Re: Round 1 Review Comments - PC 16-024

PC#16-024

PLAN COMMISSION PC #16-024 Police Station Redevelopment 200 E. Sigwalt St. PUD Amendment to Ord #78-026 Round 1

Police Station Redevelopment

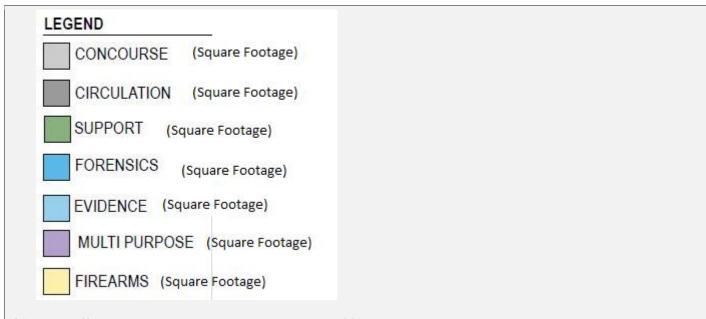
18. Please revise the elevations to show proposed building heights, including height to peak of roof, height to eaves, and height to midpoint between roof and eaves.
